Daimler Trucks North America

**RE: Defect Information Report – Supplemental Report No. 4
11V-330, FL-609, Starter Cable Isolator Bolts
Dealer Notice**

Subject: Starter Cable Isolator Bolts

Models Affected: Specific Freightliner Cascadia, Century Class S/T, Columbia, and Coronado vehicles; Sterling A/L-Line vehicles; and Western Star 4900 and 6900 vehicles manufactured January 14, 2008, through June 15, 2011, with a Detroit Diesel DD15 or DD16 engine and a certain rubber isolator.

Fig. 1, Installation that Requires Replacement

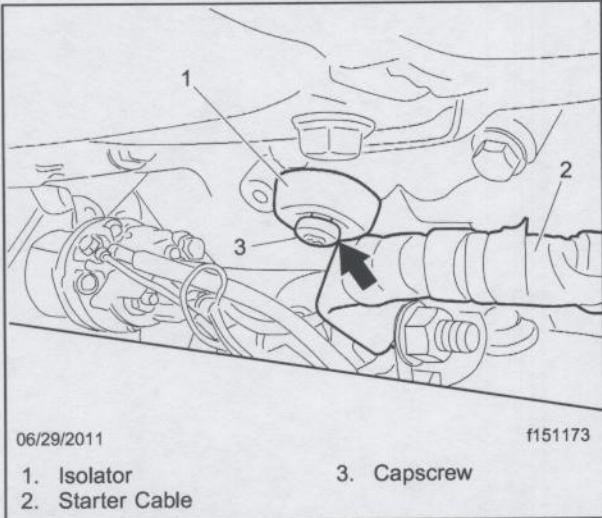
On some vehicles equipped with a Detroit Diesel DD15 or DD16 engine, the bolt attaching a rubber isolator to a support bracket may become loose and back out, potentially contacting an un-fused starter cable and creating a short circuit. A short circuit between an un-fused starter cable and chassis ground could result in a vehicle fire.

4. Remove the capscrew, washer, and isolator from the side of the engine, then discard them. See **Fig. 1**.

Fig. 2, Installing Isolator with Nylon Push-Rivet

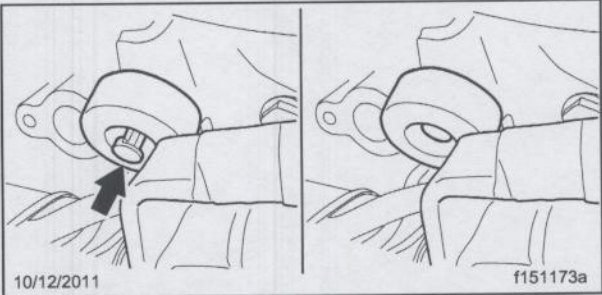
A new rubber isolator will be installed with a push-in rivet. If a vehicle has had an interim repair, it still requires this final remedy.

5. Install the new isolator using the nylon push-rivet from the kit. See **Fig. 2**. There must be approximately 1/2-inch (13 mm) of clearance between the isolator and the starter cable.
6. Connect the batteries.
7. Clean a spot on the base label (Form WAR259) and attach a completion sticker for Recall FL609 (Form WAR260) to the base label.
